# UNITED STATES PATENT AND TRADEMARK OFFICE

APPLICATION NO.	FILING DATE	FIRST NAMED INVENTOR	ATTORNEY DOCKET NO.	CONFIRMATION NO.
10/799,307	03/12/2004	Jac-Hyun Kim	8054-50 (LW9007US/HJ)	8101
22150 7590 11/21/2007 F. CHAU & ASSOCIATES, LLC 130 WOODBURY ROAD WOODBURY, NY 11797			EXAMINER CHIENT, LUCY P	
			ART UNIT 2871	PAPER NUMBER
			MAIL DATE 11/21/2007	DELIVERY MODE PAPER

**Office Action Summary**

## **DETAILED ACTION**

**FIG. 3B**

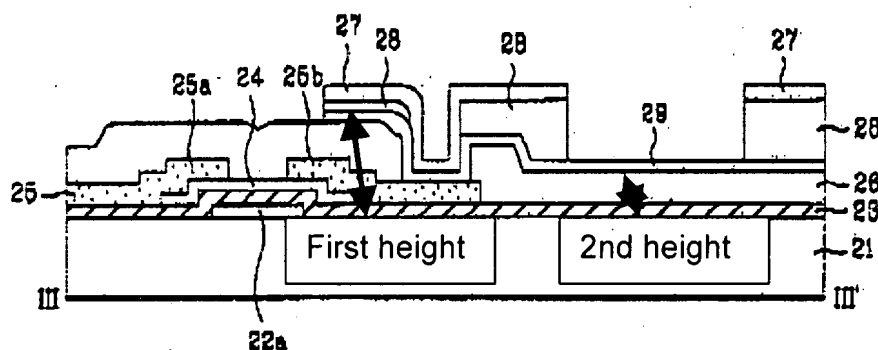
Kim et al discloses (Fig. 3b) a switching device (22a) formed in a pixel area that is defined by a gate line (22a) and a source line disposed on the first substrate, the gate line extended in a first direction and arranged in a second direction substantially perpendicular to the first direction, the Source line extended in the second direction and arranged in the first direction (shown in Fig. 3a); a pixel electrode (29) connected to a drain electrode (25b) of the switching device; and a reflecting plate (27) disposed on the pixel electrode (29) so as to define a reflecting area from which the natural light is reflected and a transmitting area through which the artificial light is transmitted, wherein the pixel electrode (29) has a first height at the reflecting area (shown below) and a

second height at the transmitting area, wherein the first height is greater than the second height with respect to the first substrate (21), and wherein the reflecting plate (27) has a first edge extended to the transmitting area an insulating layer (26) formed on the switching device and the first substrate with a first contact hole through which the drain electrode (25b) is partially exposed; and an organic insulating layer (28)(Column 6, row 64) formed on the reflecting area with a second contact hole corresponding to the first hole so as to expose the drain electrode (25b).

Kim et al does not disclose the reflecting plate has a first edge extending into the second area (transmissive area).

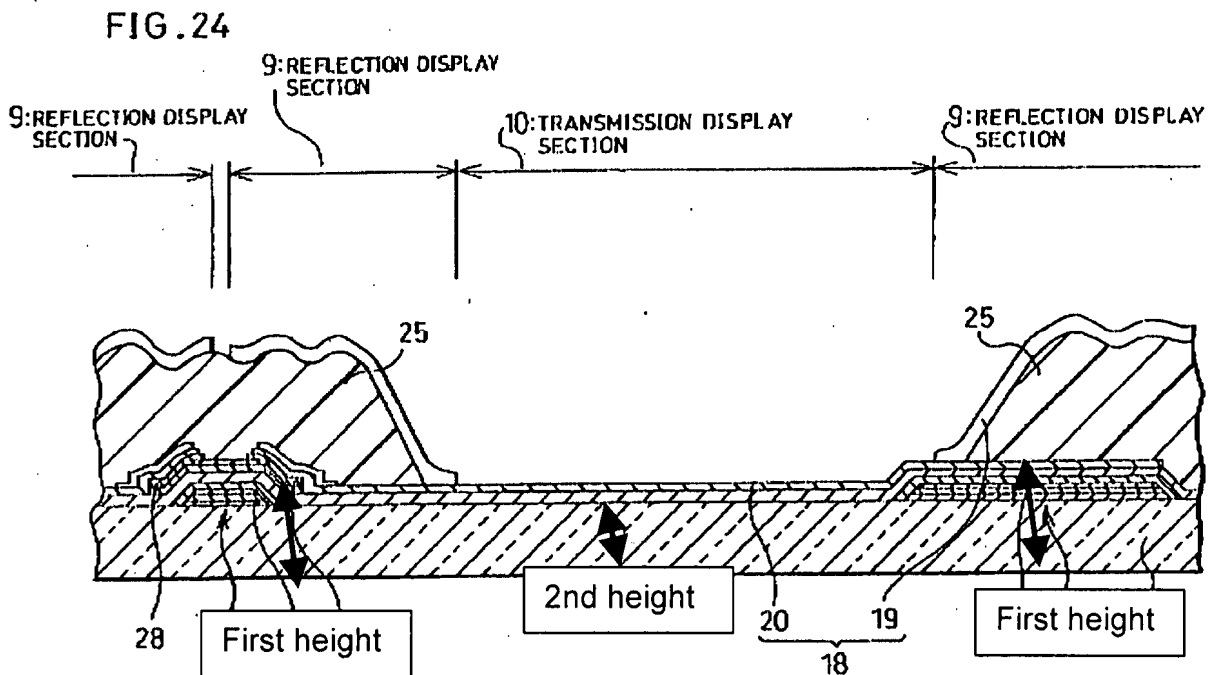
Kim et al and Nakashima et al do not disclose that the color filters corresponding to the reflecting regions have a larger thickness than the transmissive region color filter and wherein the pixel electrode has a first height at the reflecting area and a second height at the transmitting area wherein the first height is greater than the second height with respect to the substrate

Baek et al discloses (Page 3, [0037]) the color filter layer in the transmitting portion is twice as large as the thickness of the color filter in the reflective portion to improve the color purity of the light passing through the color filter in the transmissive region. (Page 2, [0014], [0015]) therefore the pixel electrode has a first height (d3) at the reflecting area and a second height (d4) at the transmitting area wherein the first height is greater than the second height with respect to the substrate.
